Product Advisory (PA)

Subject: Introduce New T-type End Plug for n-SOIC rail (packing tube)

Publication Date: 6/8/2016

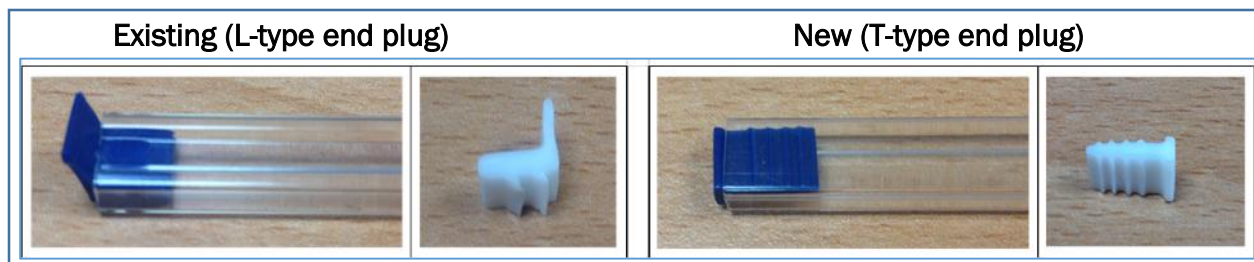
Introduce new T-type end plug for n-SOIC rail (packing tube)

The L-type (existing) and T-type (new) end plug could be identified visually. The removal tab on the end plug appears as “T” shape for better locking to the rail (packing tube), which will

reduce loose end plug issue. There is no change to the color, material and critical dimension of the end plug and rail (packing tube).
